October 14, 2021

**Subject: Certified Vernal Pool Analysis at Proposed “Village at Cricket Lane”
Newbury, MA**

As I mentioned previously, I have been retained by direct abutters to the proposed Villages at Cricket Land project (the “Project”) located at 55 Pearson Drive (the “Property”) in Newbury to assess whether the Project complies with the MassDEP Wetland Protection Act (WPA) and more particularly, protects both the northerly Certified Vernal Pool (“CVP”) and the westerly Potential Vernal Pool (“PVP”).

Figure 2. Post-development CVP watershed.

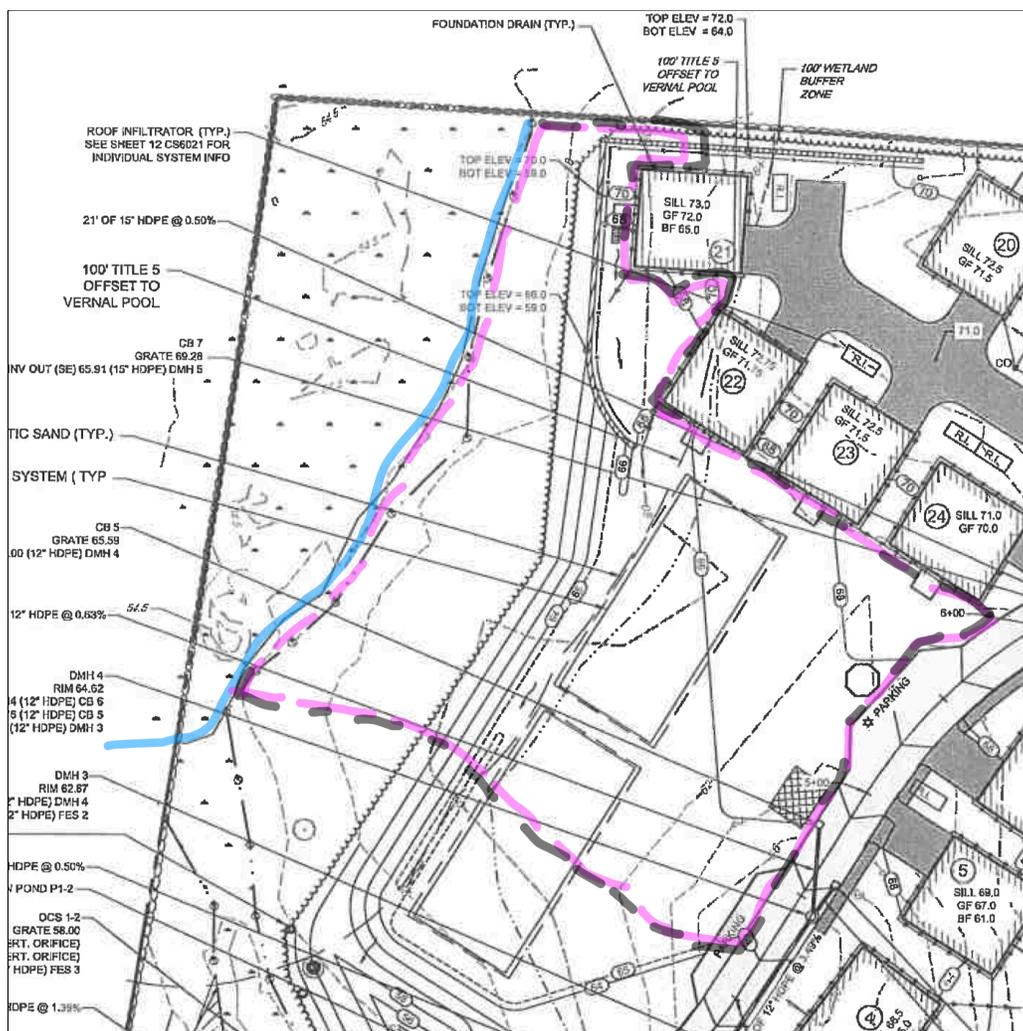
To calculate potential CVP water budget changes, I first determined the *pre-development* project-related watershed area for the CVP, which is 1.76 acres. I then determined the watershed area for the CVP after (or post) development. The post-development watershed area — 1.04 acres — *decreased* by 40%, which itself is a significant alteration.

Regardless, groundwater movement is typically disrupted or redirected by site “improvements” such as roads, drainage infrastructure, subsurface infiltration, retaining walls and foundations. All of these disruptions would occur on the Project site. More than 50% of the Project CVP watershed is substantially altered after development, and more than 90% of the PVP watershed.

Therefore, my professional opinion is that the natural groundwater flows into the CVP are likely to be altered by the Project. Because project data provided by the Applicant’s designer is insufficient — that is, information regarding directional groundwater flow is missing — specific analysis of this component is not possible. Consequently, the focus of my analysis has been on the components I can reliably quantify, which are the changes to surface runoff described in this report.

Subcatchment 1S: Pre-Dev VP Subcatchmt

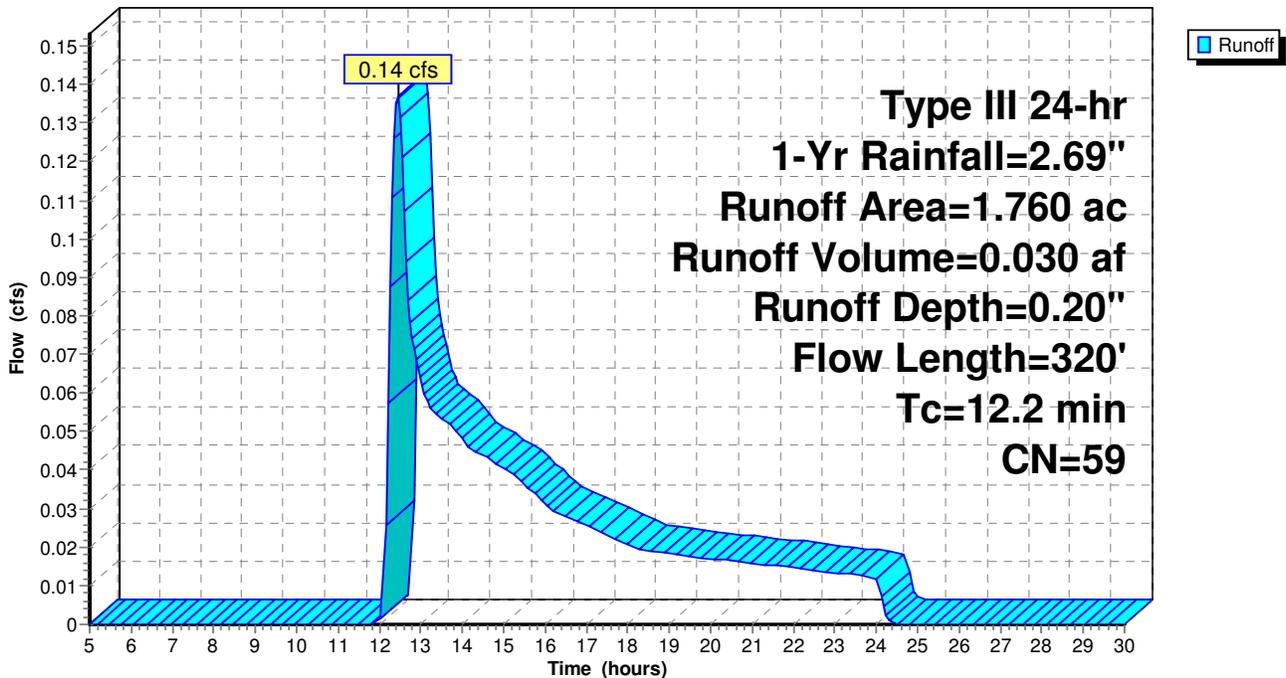
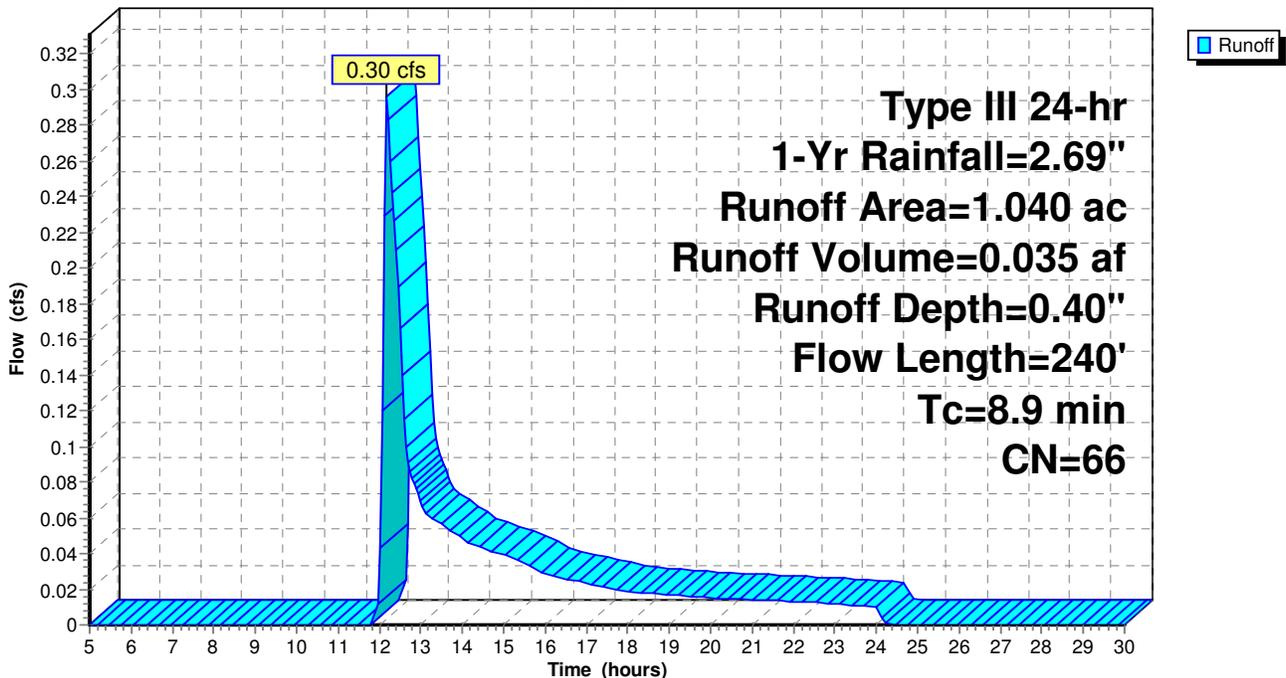
My calculations indicate that the CVP would be adversely impacted by the Project. CVP impacts are found in all measurable parameters, such as watershed area, impervious area, runoff velocity (measured in cu. ft/sec, or cfs), and volume, which are illustrated in Tables 1 and 2 below.

- the volume of stormwater entering the CVP increases by 14%;
- the timing of volume entering the pool by increases by 23%;
- the amount of impervious area in the CVP watershed increases by 13%;
- the depth of stormwater entering the pool increases by 50%; and
- the velocity of stormwater entering the CVP watershed increases by 53%.

Of particular note, times of concentration (Tc — the time it takes water to travel from the highest point in a watershed to the lowest) of stormwater flow will be markedly decreased, with frequent, low-intensity storm events far more likely to flow into the CVP than under existing conditions.

Compounding the impacts, the flow length (that is, the total distance stormwater flows from one end to another through a watershed) is reduced after development. The existing flow length for the CVP is 320 feet; under proposed conditions that length is decreased by 80 feet. This 25% decrease in length is a significant change that would, when combined with a shortened Tc, increase the impact of frequent, low-intensity storm events.

To maintain the fragile habitat characteristic of a vernal pool, a site designer normally strives to ensure that the annual water budget post-development, including runoff characteristics, is in balance with pre-development conditions. In the case of this Project, there appears to be no attempt to mimic pre-development hydrologic characteristics for the CVP.
